Re: Smiths Fuel Center #459, 7525 Holly NE
Permanent Certificate of Occupancy – Transportation Development
Engineer's Stamp dated 05-31-11 (C19-D054)
Certification dated 05-31-11

Re: Smith's Fuel Center #459, 7525 Holly Ave NE, Grading Plan Engineer's Stamp dated 10-27-10 (C19/D054)

SMITH'S FUEL CENTER #459
7525 Holly Avenue NE

Re: Smith's Fuel Center #459, 7525 Holly Ave NE, Grading and Utility Plan Engineer's Stamp dated 9-22-10 (C19/D054)

TITLE: **Grading Plan**
SMITH'S FUEL CENTER #459
7525 Holly Avenue NE

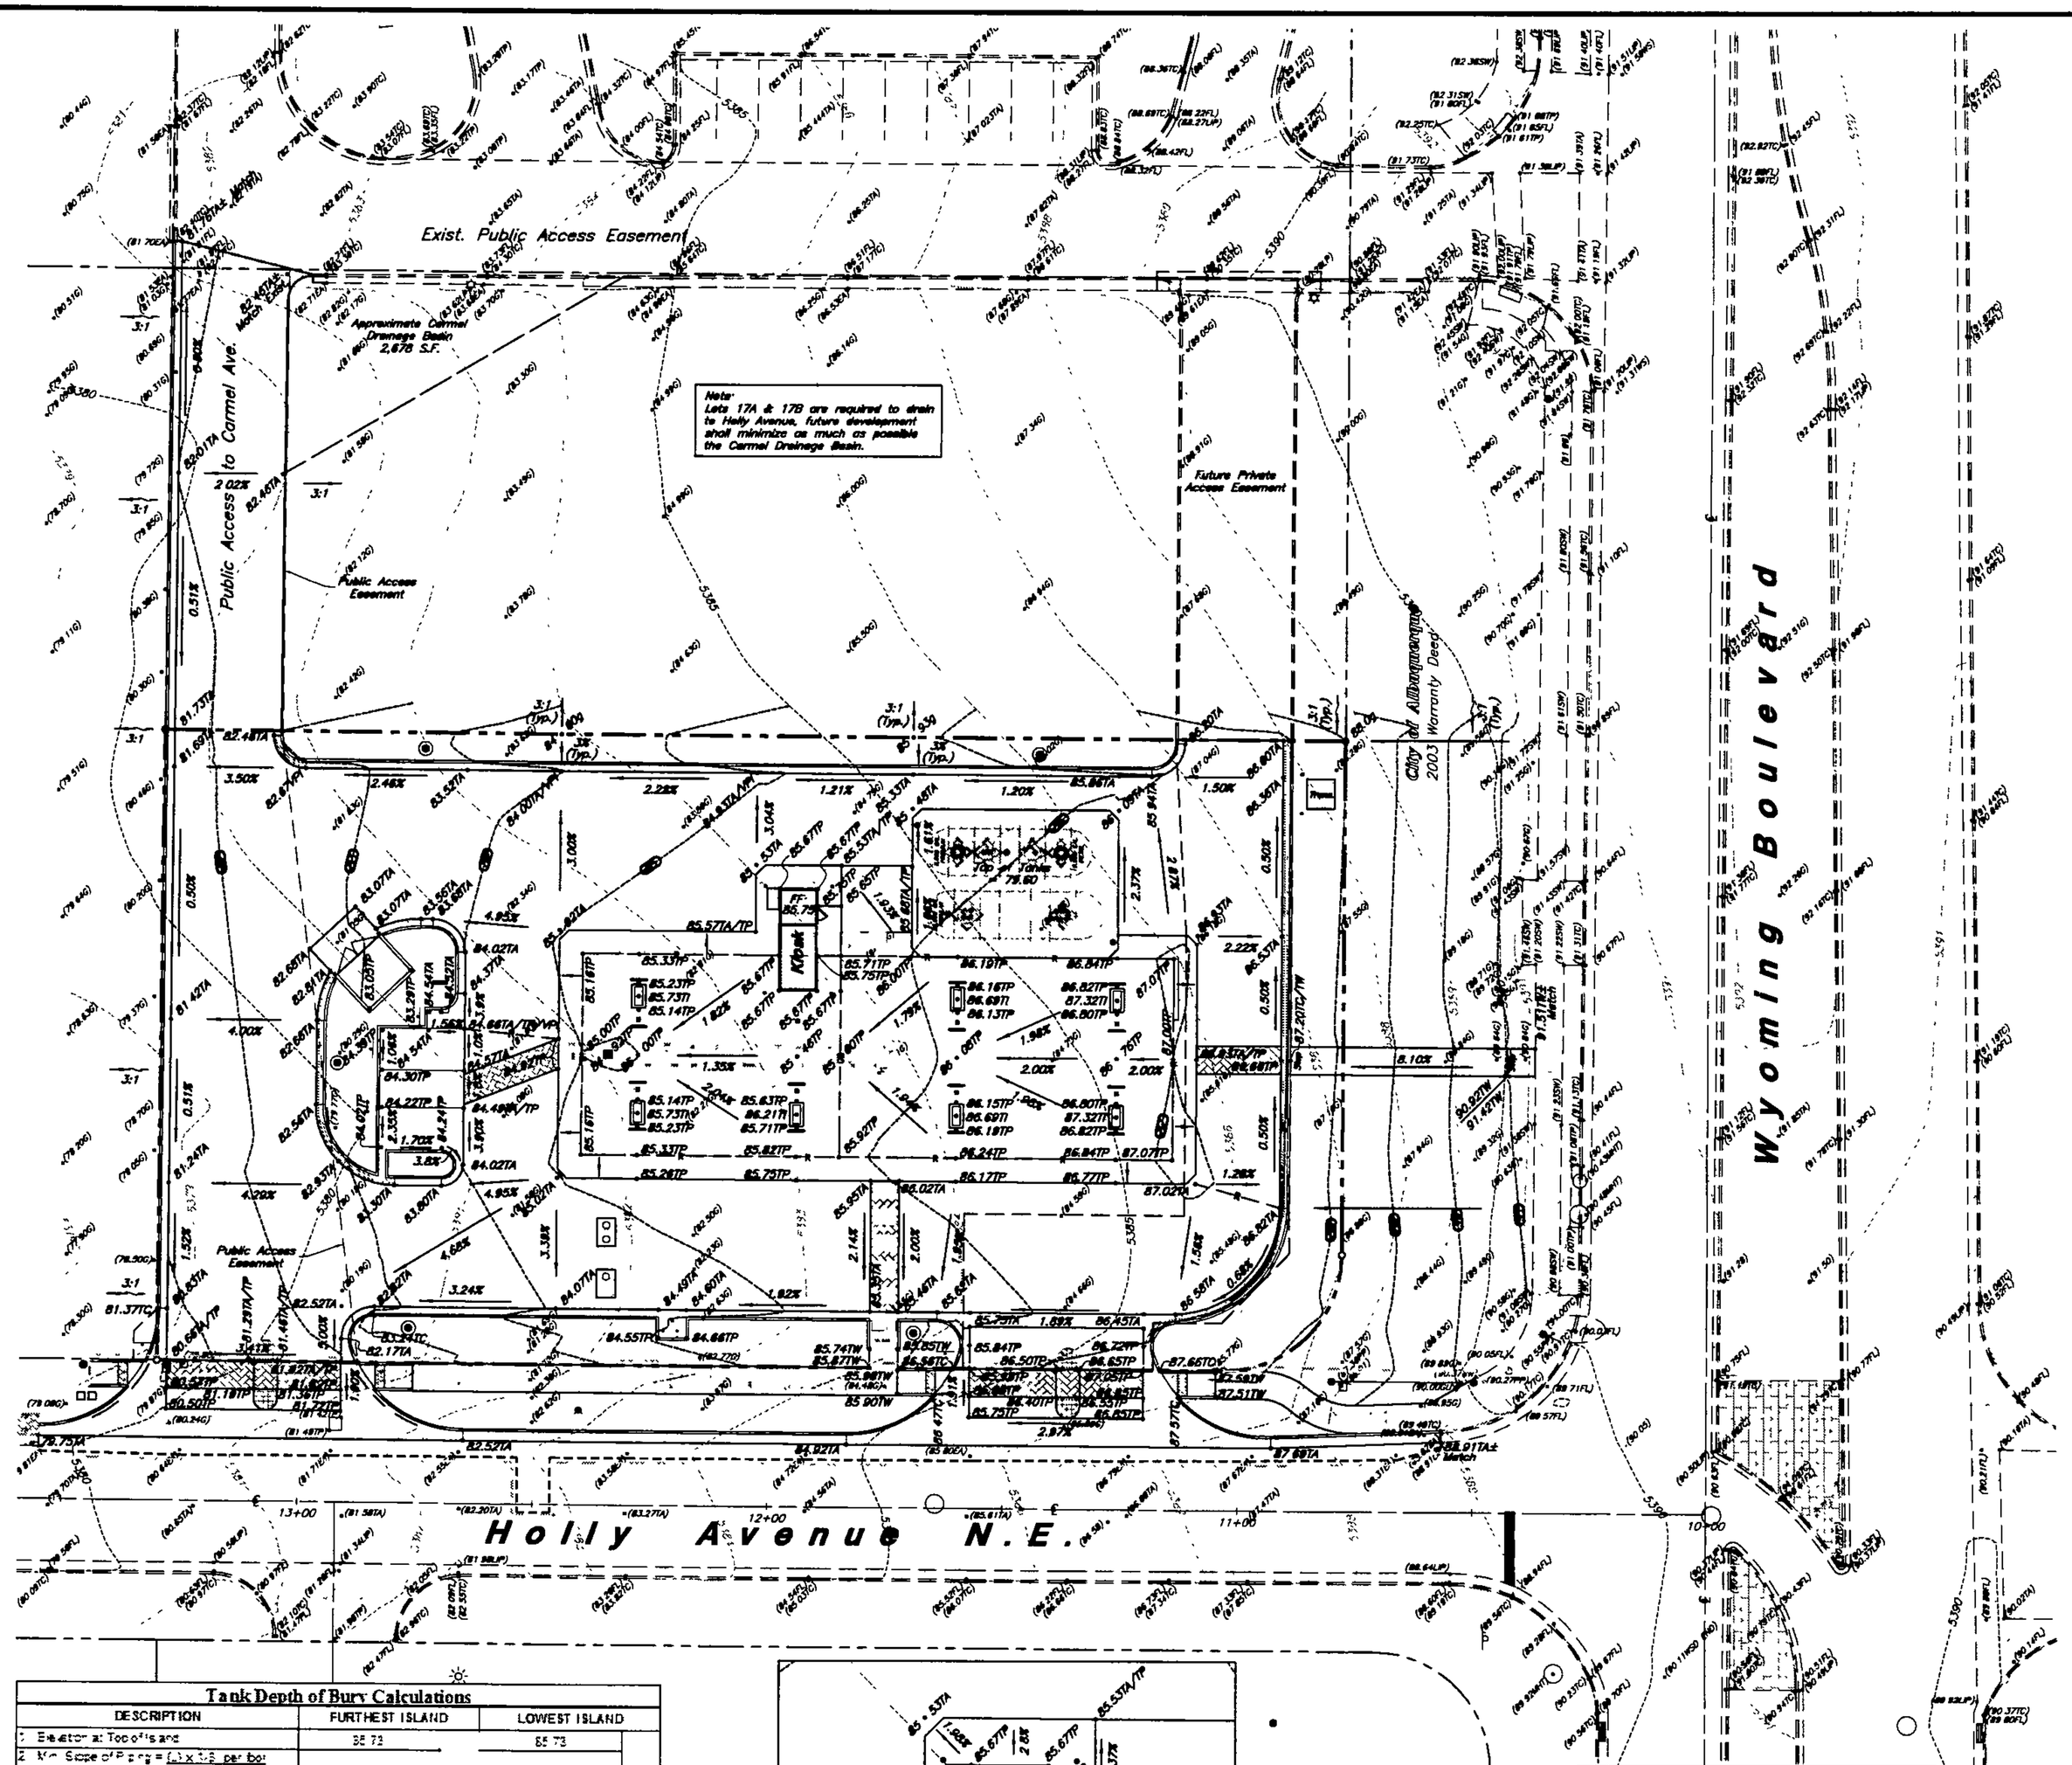
- The energy dissipator along the western edge of the project should be adjacent to the edge of pavement.

- *This plan proposes grading West of the site. Approval from that property owner is required.*

- *Provide proposed contours.*

- *Provide spot elevations at the South corners of the cut-out in the landscaping near Holly Ave.*

- This plan proposes grading west of this site. Approval from that property owner is required.
- Provide proposed contours.
- A higher water block should be proposed at the drive entrances off Holly Ave. A water block of 0.33 ft from the south edge of the new sidewalk to the flow line elevation would work.
- Provide spot elevations at the south corners of the cut-out in the landscaping near Holly Ave.
- The drain lines through the curb will be built by Work Order.

Finish contours have been shown on the attached grading plan.

The drain line has been added to the work order plans as requested.
